UNITED STATES PATENT AND TRADEMARK OFFICE

APPLICATION NO.	FILING DATE	FIRST NAMED INVENTOR	ATTORNEY DOCKET NO.	CONFIRMATION NO.
10/508,920	09/23/2004	Bae Yun-Ki	31758-207631	8301
26694	7590	02/15/2007		
VENABLE LLP P.O. BOX 34385 WASHINGTON, DC 20043-9998			EXAMINER VANAMAN, FRANK BENNETT	
			ART UNIT 3618	PAPER NUMBER
SHORTENED STATUTORY PERIOD OF RESPONSE			MAIL DATE	DELIVERY MODE
3 MONTHS			02/15/2007	PAPER

Office Action Summary

FIG. 5

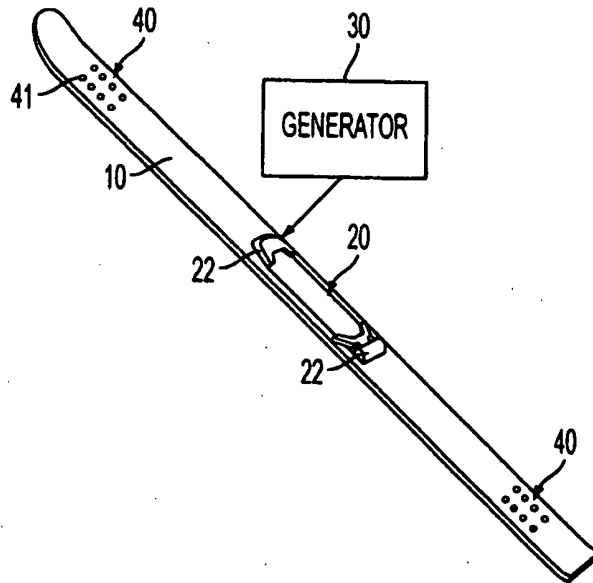
3. The proposed drawing correction, filed Dec. 22, 2006 has not been approved. The proposed new figure 5 includes what is asserted to be a binding plate as well as bindings. The provision of a binding plate separate from the bindings is not supported by the original specification and drawings as filed.

NOT
APPROVED
FBV
2/8/07

Exemplary Drawing

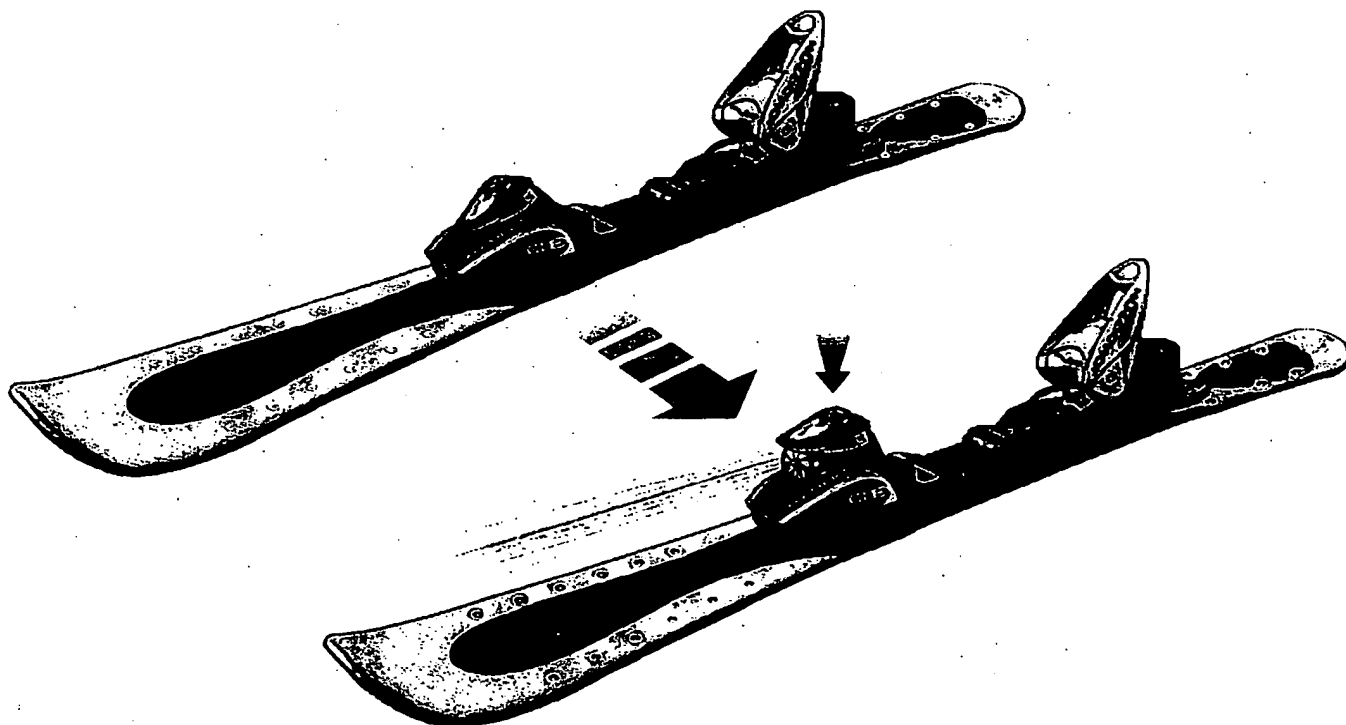
provided. Applicant's comments concerning the exemplary drawing are noted but are not persuasive. Firstly, these comments are based on material that was not present in the application as filed, and as such, material which does not constitute a part of the specification. Note that 35 USC 112, first paragraph requires that: "The specification shall contain a written description of the invention, and of the manner and process of making and using it, in such full, clear, concise, and exact terms as to enable any person skilled in the art to which it pertains, or with which it is most nearly connected, to make and use the same, and shall set forth the best mode contemplated by the inventor of carrying out his invention."

Secondly, the comments filed in association with the exemplary drawing (page 10 of the amendment papers) appear to be speculation, e.g., the binding which can somehow be opened or closed to allow exposing of the rotation wing; and are not actually based on the disclosure as filed. Applicant has not pointed to a binding structure, as disclosed in the application, that can allow such possible opening or closing, nor has applicant pointed to a binding structure as disclosed in the application, that can accommodate a rotary permanent magnet and induction coils assembly therein. If the application as filed is asserted to support the claims as currently written, then it is not clear why applicant relies on (1) "exemplary" drawings which were not part of the application as filed or (2) a speculative description which was also not part of the application as filed.

NOT PART OF
APPLICATION
DRAWINGS
